STATE OF MARYLAND APPLICATION FOR PERMIT TO DRILL WELL

HO-15-0070 fill in this form completely

RE: **Replacement Well Sampling**  
7218 Meadow Wood Way  
#HO-15-0070

**SITE INSPECTION SHEET**

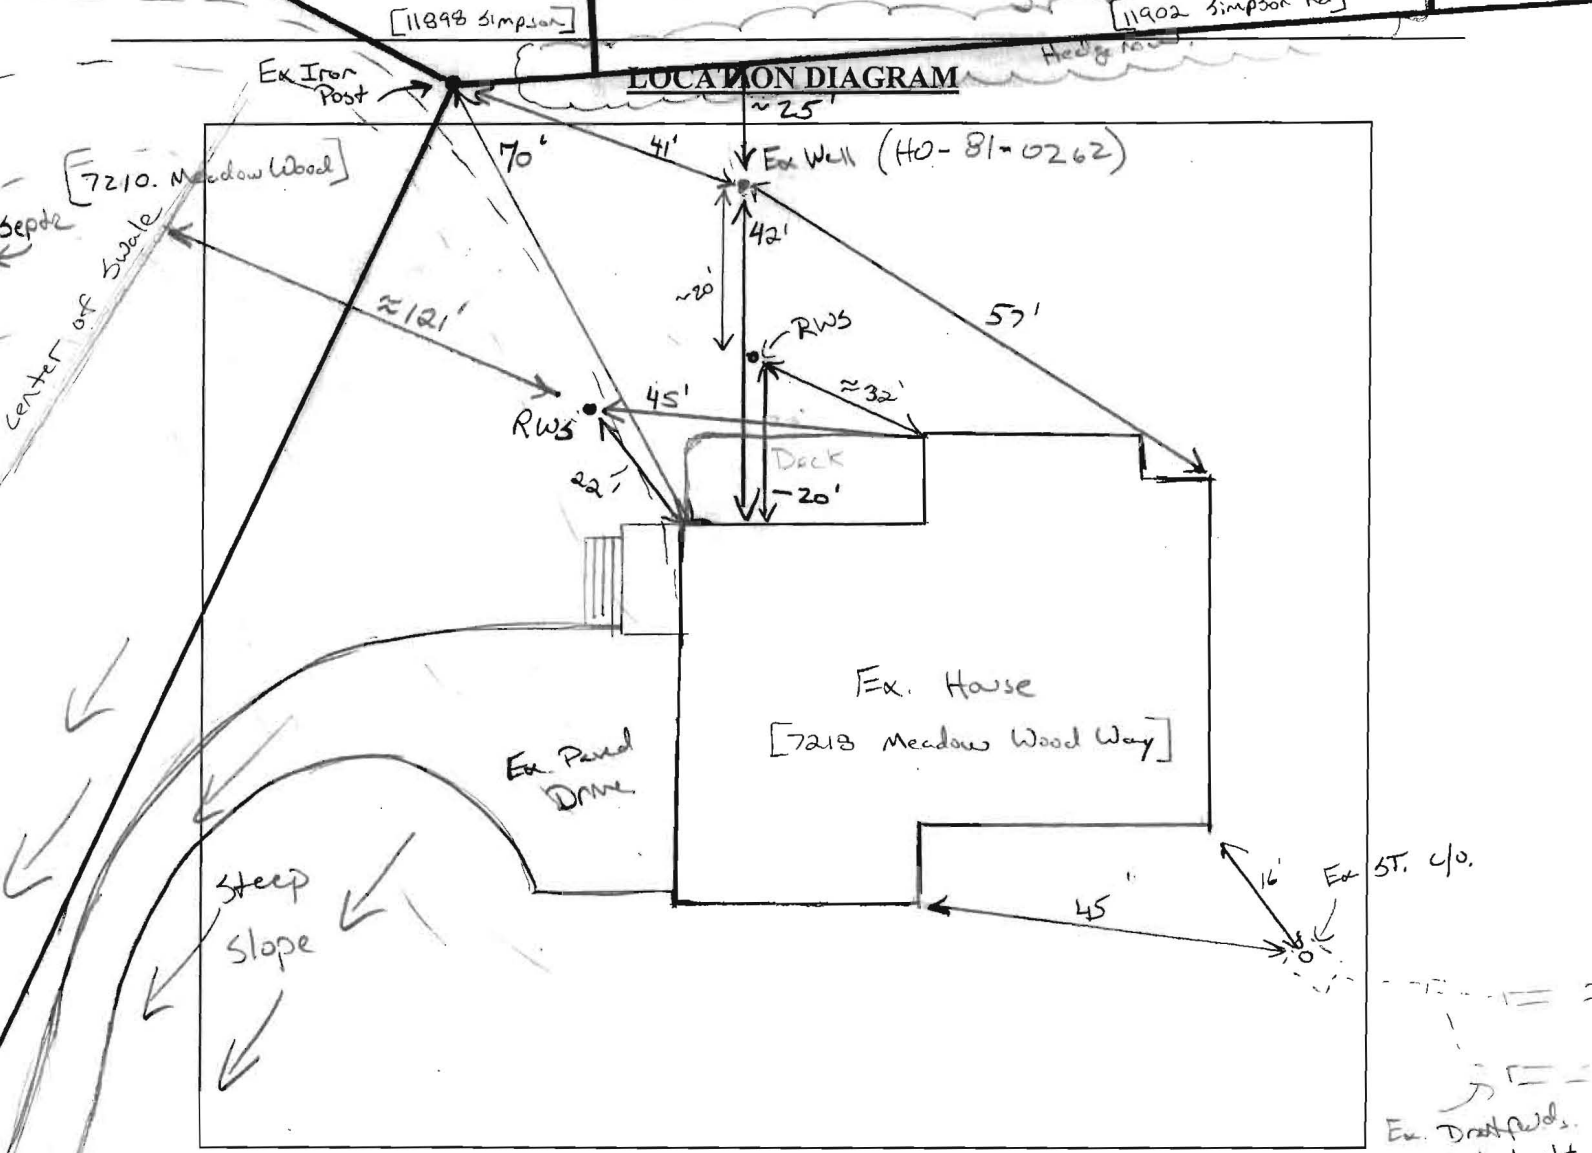
COMMENTS: 3/30/15 Possible location's made. Can not approve @ this time. 4/12/15 Need to research adjacent properties SRA. Very tight lot. (KW)

4/8/15 OK to approve 2 location's shown. Replacement well location's staked out in field. (KW) Only possible location's are to move closer to house. OK to go less than 30'.
